**VALUE ENGINEERING SUMMARY
OF
I-75 WIDENING
BETWEEN KY 192 AND KY 80
LAUREL COUNTY, KENTUCKY**

APRIL 13-17, 1998

EXECUTIVE SUMMARY

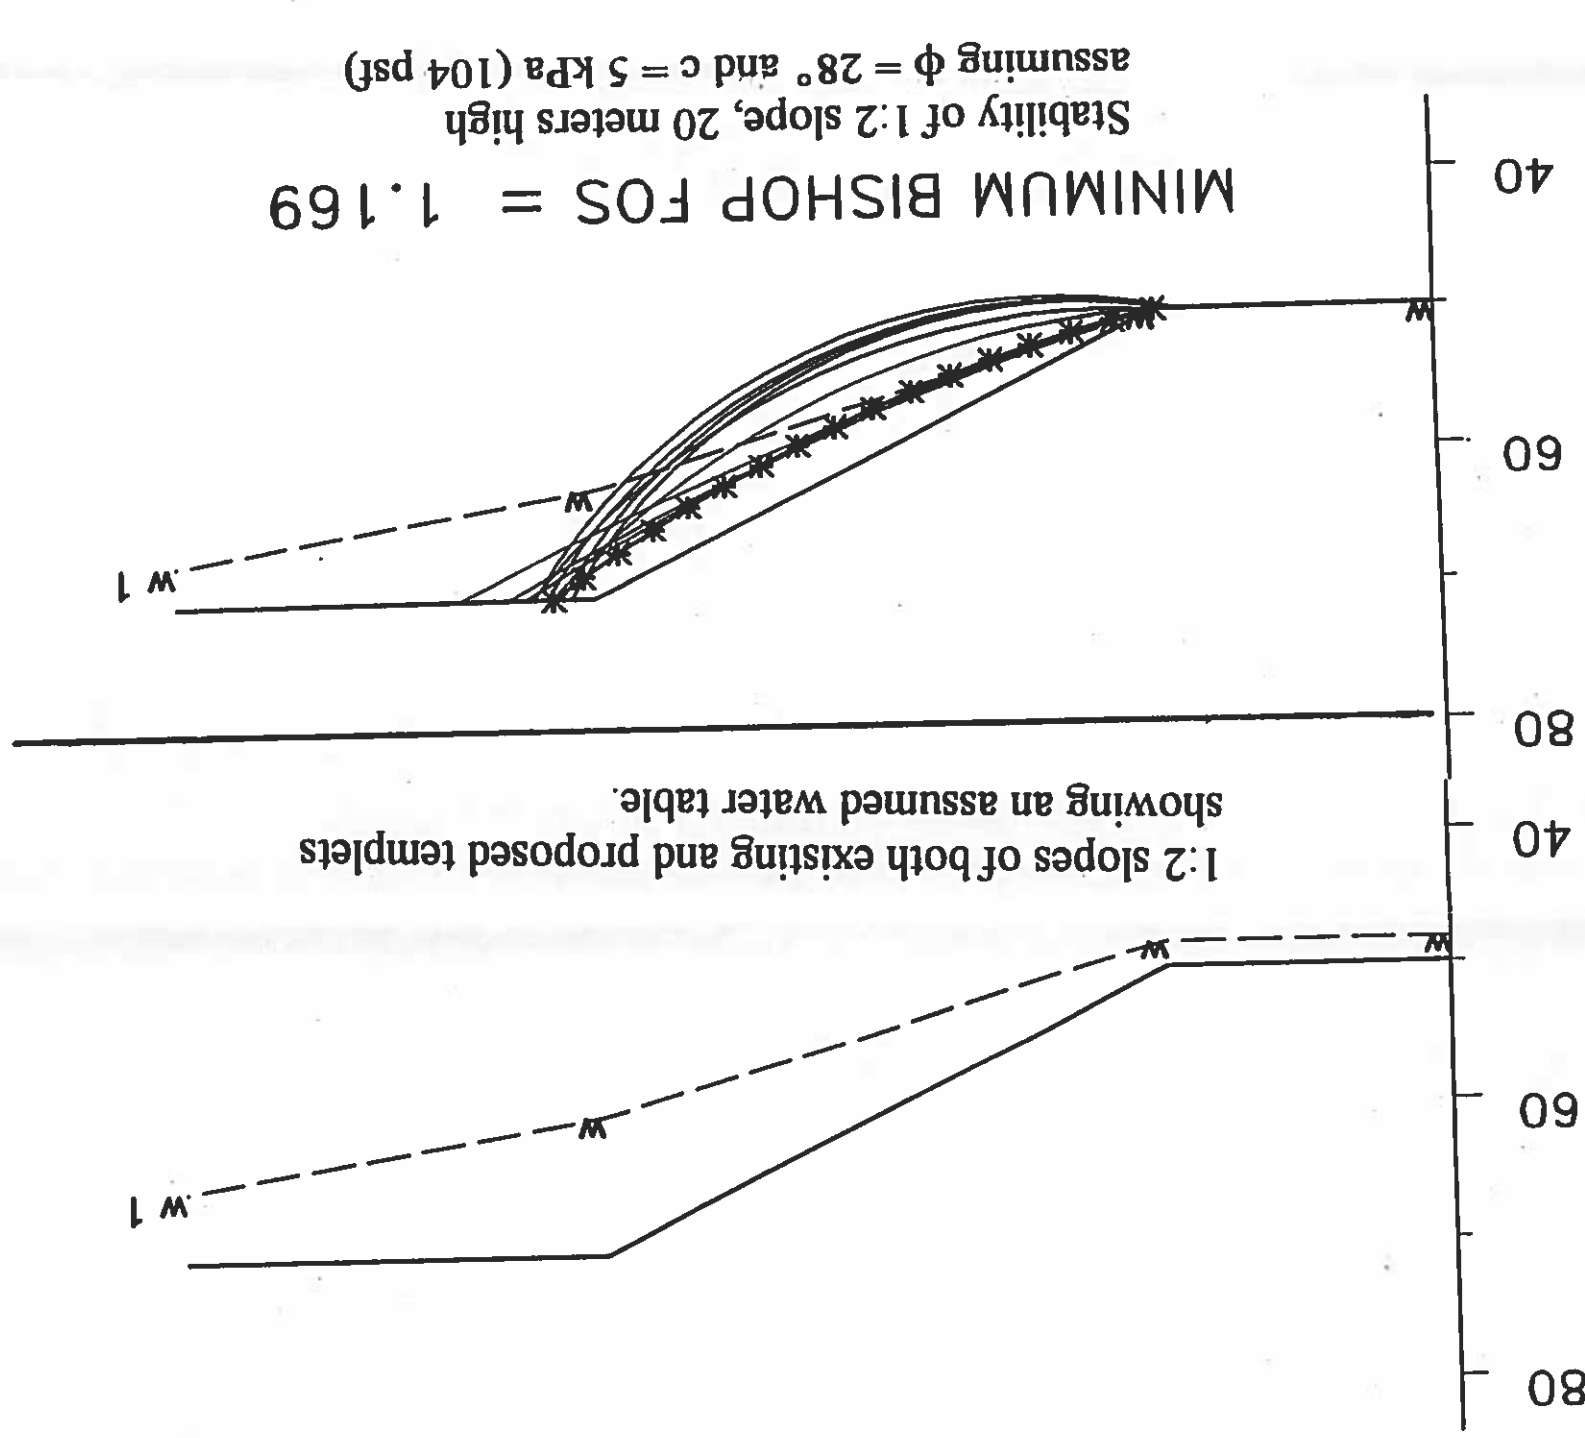
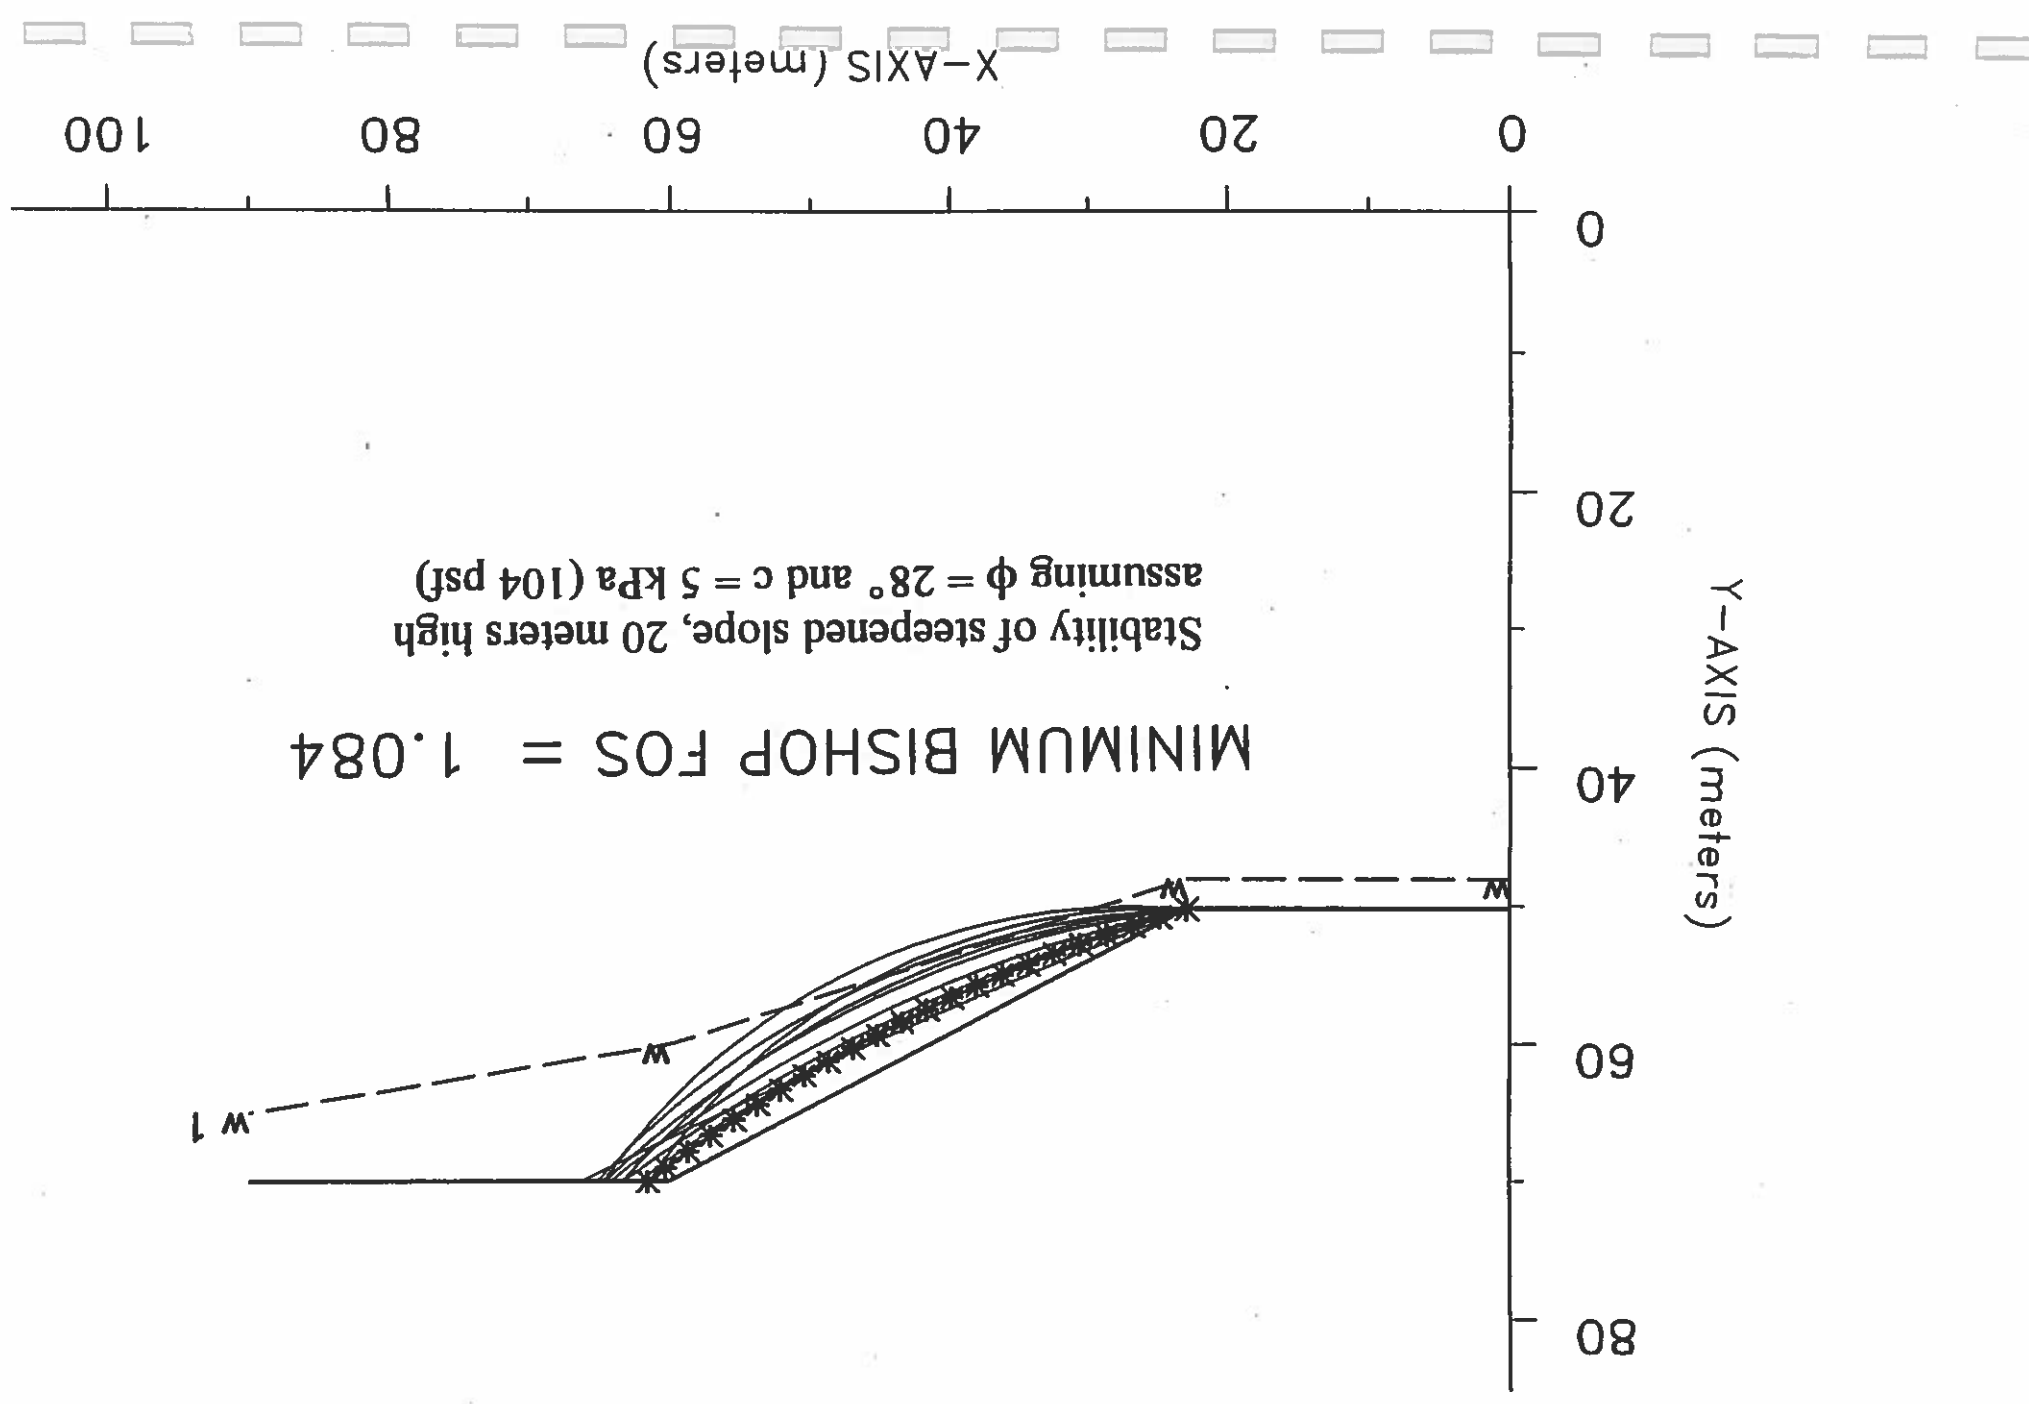
Stability analysis was performed for the left slope of the culvert at Sta. 64+627. This is probably the most critical section. The embankment is approximately 20m in height and a 1.5m of additional material is being added. The "Proposed" change in slope angle is from 1:2 to 1:1.8. Assuming soil strength parameters of $\phi = 28^\circ$ and $c = 5\text{kPa}$, the factor of safety of the 1:2 slope is 1.17. The steepened slope for the same soil strength parameters fell, but only to 1.084. Thus, assuming that stability of the embankment currently is only marginal, steepening the slope does not have great impact upon stability. Although there is some risk involved (the safety factor lower), the proposed change is safe unless the existing configuration is also at imminent failure. The cost to benefits ratio seems to favor steepening the slopes to eliminate the culvert extensions.
